Rezoning Transportation Analysis

Petition Number: 2018-024

From: CDOT Land Development Section

Date	Description
03-21-18	First Review
04-23-18	Second Review

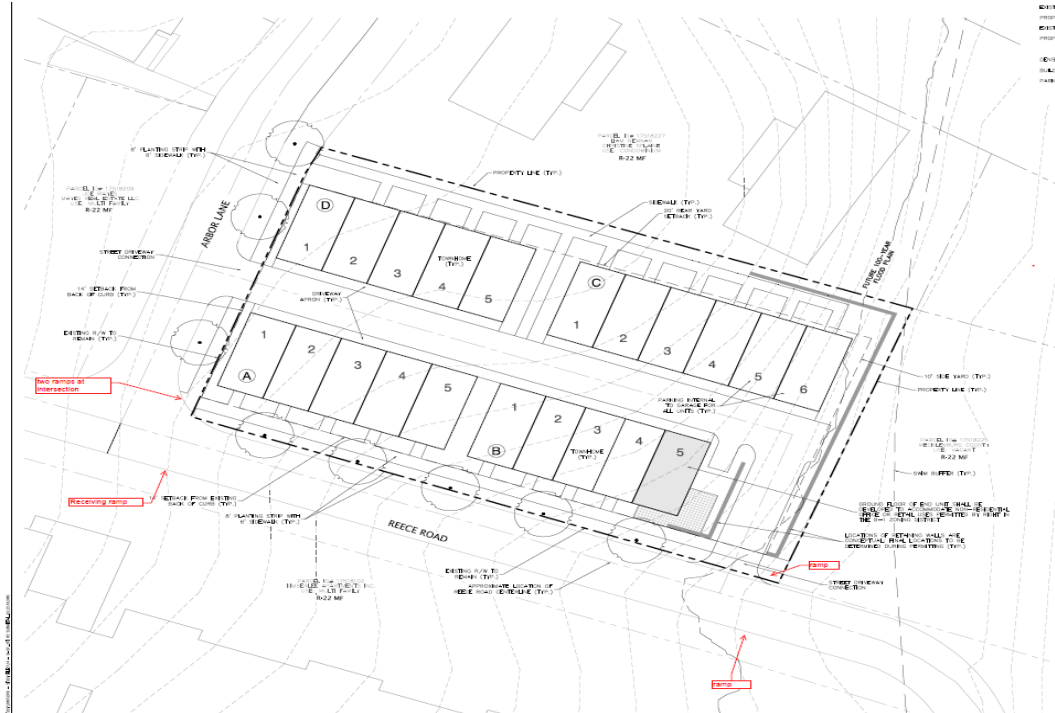
This site is bounded by two local roads. The site commits to installing ramps on Reece Road, 8' planting strip and 6' sidewalk. CDOT has a concern about the northern proposed tree on Arbor Lane as it relates to the proposed sidewalk connecting to existing sidewalk.

- ~~**Curbline** The proposed zoning district has a setback measured from back of the existing or proposed future curbline. The location of the future back of curb is the existing back of curb.~~
- ~~**Traffic Study** A Traffic Impact Study/Transportation Technical Memorandum is not necessary for the complete review of this petition.~~
